Towards a more representative parametrisation of hydrological models via synthesizing the strengths of particle swarm optimisation and robust parameter estimation” by T. Krauß and J. Cullmann

T. Krauß and J. Cullmann

Interactive comment on Hydrol. Earth Syst. Sci. Discuss., 8, 2373, 2011.

Fig. 1. Figure 6a

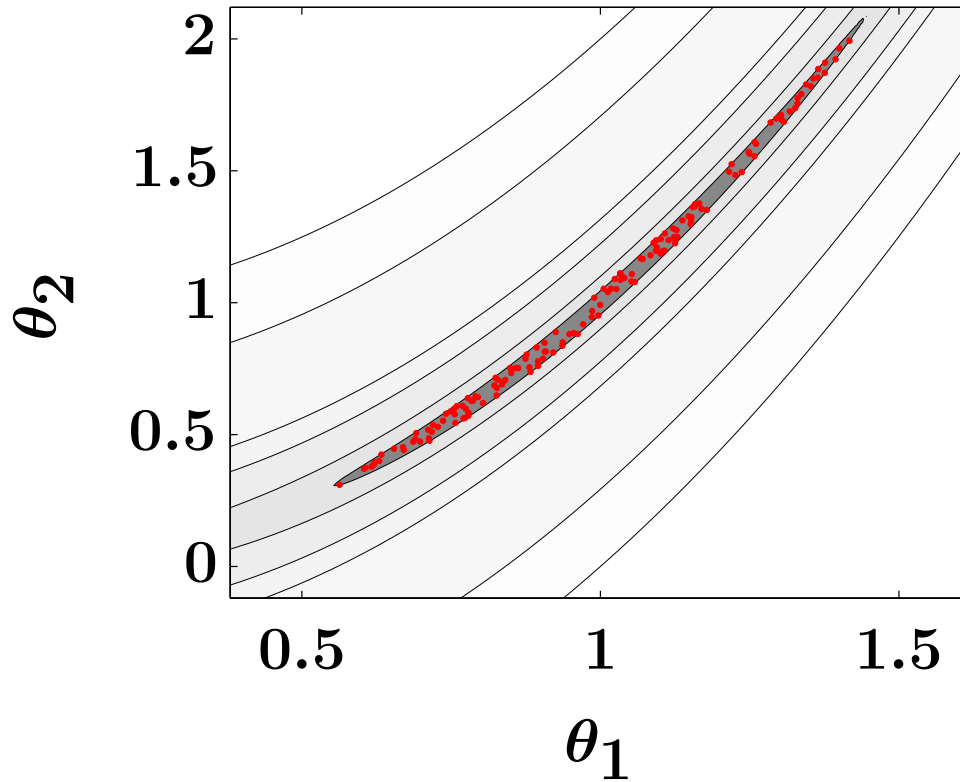
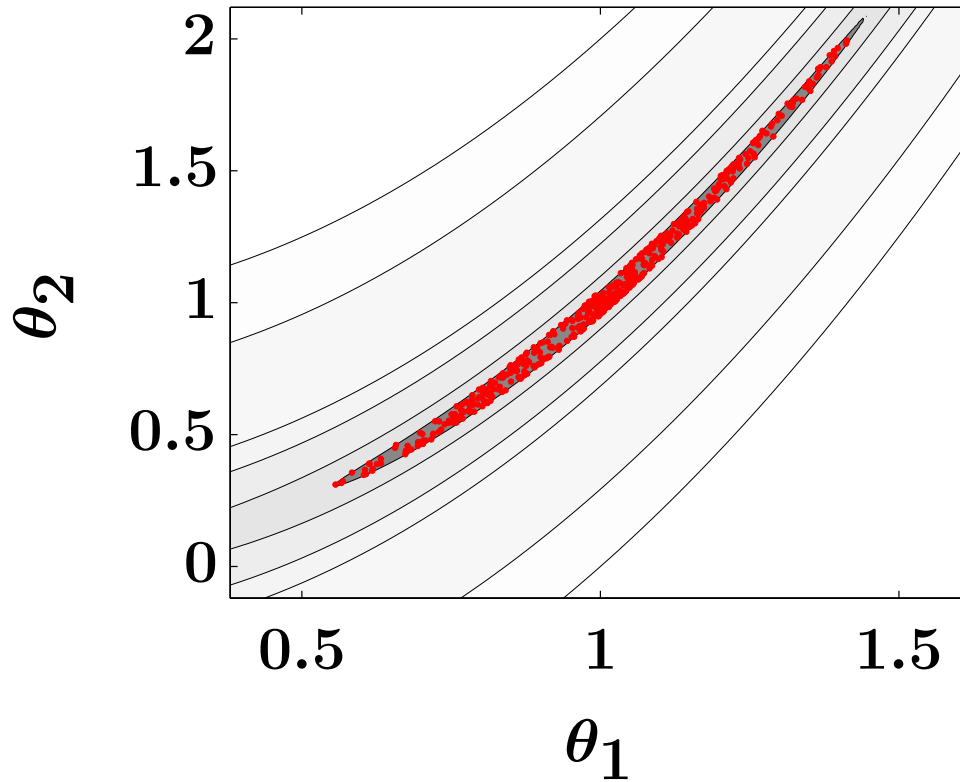
>PSO and other randomized search methods were not designed as uncertainty analysis methods. This means that >the vectors generated do not necessarily follow cover the space well and/or follow the prior distributions - which is >done by standard MC procedures. The objective of PSO and similar methods (like GA, ant colony optimization, >adaptive cluster covering, SCE-UA, AMALGAM, etc.) is to quickly move towards the global optimum, so that the >parameter space will not be thoroughly explored. There have been studies reported when such methods were >indeed used for uncertainty analysis as well, but there is of course no surprise they are more economical since >they are not geared towards exploration of parameter space. I would suggest providing some brief discussion on >this issue, or at least mentioning this. I would also suggest to provide references to the methods of “economical” >uncertainty analysis (sampling) that are combining ideas of on random search methods and MCMC

Metropolis >algorithm (SCEM-UA, DREAM, etc) – see papers by Vrugt and co-authors.

We introduced a brief discussion on this issue into the introduction section. Furthermore we provide some results that support the ability of the developed PSO based approach PSO-GA_u for the estimation of good parameter vectors within a larger region. They are presented in the course of the presentation of this method. Please refer to Figure 6a) and b) on page 10. We attached these figures to this comment as well.
